South Texas Project Electric Generating Station 4000 Avenue F – Suite A Bay City, Texas 77414

October 20, 2010
U7-C-STP-NRC-100232

South Texas Project
Units 3 and 4
Docket Nos. 52-012 and 52-013
Revised Response to Request for Additional Information

RAI 10.04.07-3 Response, Revision 1**Question:**

Figure 2.10.2a Condensate and Feedwater System

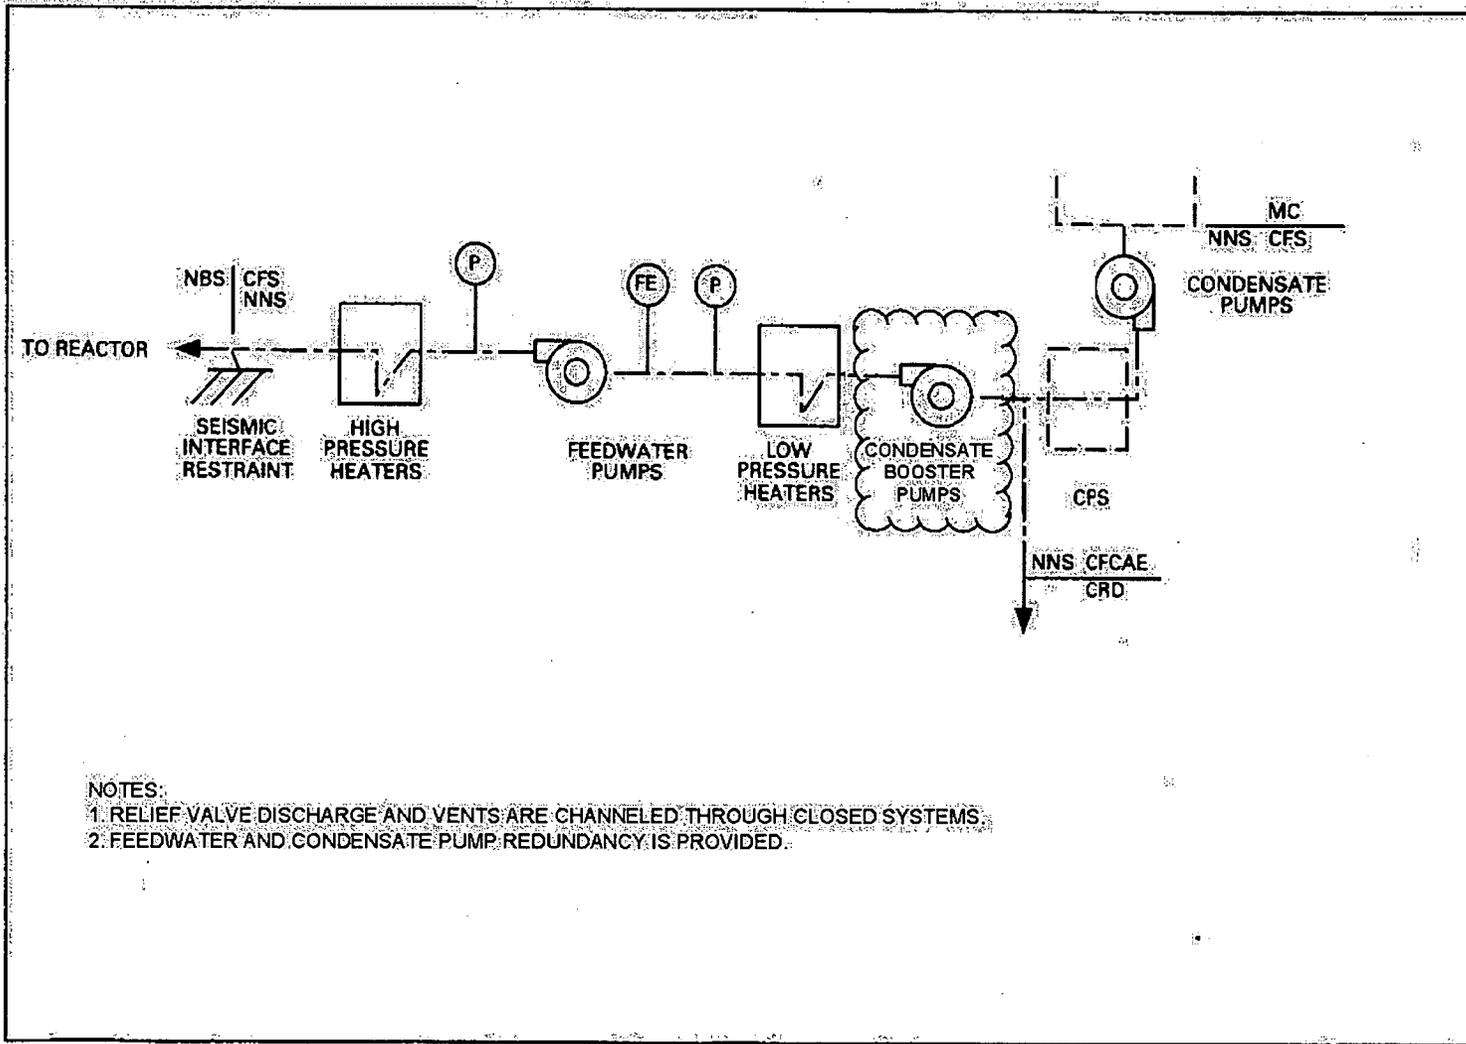
The staff previously issued RAI 10.04.07-1 (Question 359) requesting STP to provide justification as to why the information in Tier 1, Section 2.10.2 regarding the Condensate and Feedwater System (CFS) description and ITAAC was not updated to reflect design changes to the system as a result of departure STP DEP 10.4-5. In its response the applicant indicated that "the CFS alters the specific design, but does not modify the functional arrangement," and that "detailed design drawings, which will expand the basic configuration to include the condensate booster pumps along with other refinements perform these inspections." The staff found this response unacceptable since the Tier 1 design in the DCD is not consistent with the STP CFS design, and since the Tier 1 CFS information incorporated by reference is no longer reflective of the STP design.

The STP application incorporates by reference the design description, functional arrangement, and ITAAC for the CFS standard design included in ABWR DCD Tier 1, Section 2.10.2. In the STP COLA, the applicant departs from the standard design, and incorporates into the CFS additional significant SSC's. Because the COL design differs significantly from the design certified in the DCD, the ABWR ITAAC in the DCD, which confirms the certified design, is not applicable to the STP design. Provide an update to the referenced CFS design (design description and/or functional arrangement) in Tier 1, Section 2.10.2, so that the referenced ITAAC in Tier 1 Table 2.10.2a is applicable to the CFS design being licensed in the STP COLA.

As requested in RAI 10.04.07-3, STPNOC is proposing a departure to update the design description and figure showing the basic system configuration for the Condensate and Feedwater System (CFS) in Tier 1 Section 2.10.2.

As a result of this RAI response, the COLA will be revised as shown below to reflect a Tier 1 standard departure to COLA Part 2, Tier 1, Section 2.10 Power Cycle Systems. The changes are shown bubbled on Figure 2.10.2a and with grey shading elsewhere.

pumps, through the CPS to the condensate booster pumps, passes through the low pressure feedwater heaters to the feedwater pumps, and then is pumped through the high pressure heaters to the reactor. Figure 2.10.2a shows the basic system configuration. The CFS boundaries extend from the main condenser outlet to (but not including) the seismic interface restraint outside the containment.

DCD Tier 1 Figure 2.10:2a shows the basic system configuration of the Condensate and Feedwater System (CFS) with a single symbol for condensate pumps. This departure adds a second symbol to indicate the addition of condensate booster pumps in series. The CFS system is classified as non-safety-related and does not perform a safety function. The location/arrangement of the condensate pumps and condensate booster pumps, between the condenser hotwell and the low pressure heaters, does not adversely impact the ability of the CFS to perform the function described in the Tier 1 Design Description.
